**ADDENDUM #01**

**TO CONTRACT DOCUMENTS FOR:** Project #RC000451  
Ozark Field Station

BID QUESTION RESPONSE  
DATE: 03/17/2023

DRAWINGS FOR: **MS&T OZARK FIELD STATION**

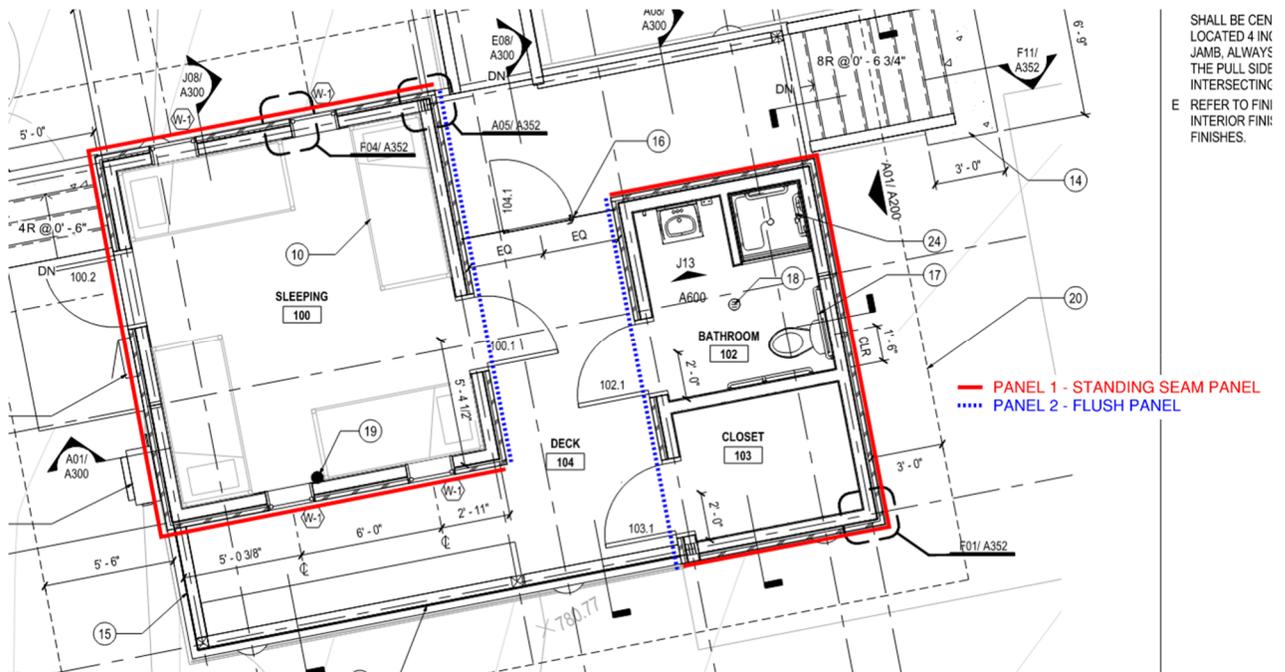
13. The hatching on the porch walls are different in places on the outside exterior wall. Do they plan on using a different panel on the porch?
  - RESPONSE: There are two types of panel being utilized for this project - Standing seam panels and flush panels. (Flush panel is just the (2) walls fancying the dog trot pass through

in the kiddie of the building. See sketch.)

DESCRIPTION HOLDING TANK SLAB

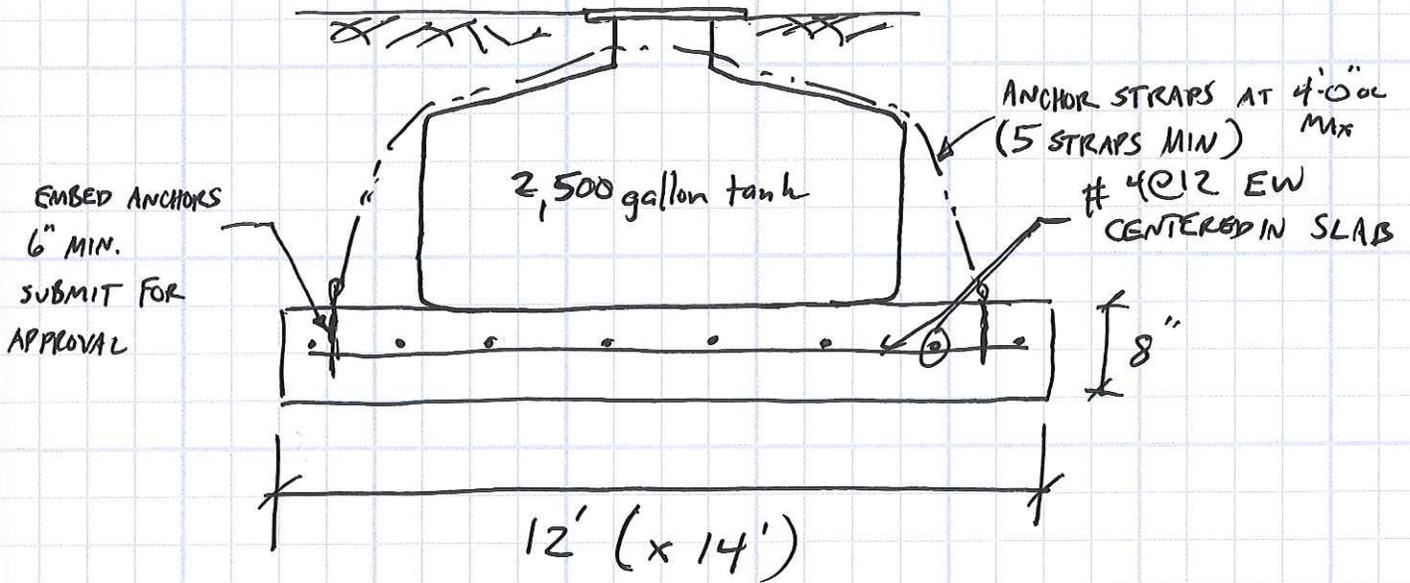
5. Due to concerns about buoyancy during saturated soil conditions, should ballast or anchors be required for the sewer storage tank?
  - RESPONSE: Contractor shall construct a 12' wide x 14' long x 8" thick concrete slab below the storage tank. Contractor shall install straps and embed anchors into slab; refer to attached conceptual sketch. Actual slab size may vary based on final submitted poly tank

and manufacturer's recommendations; however, a minimum of 4.2 cubic yards of concrete is required for ballast.

Assumed TANK DIMENSIONS APPROX. ~~8' W~~ 8' W x 13' L x 4.25' H
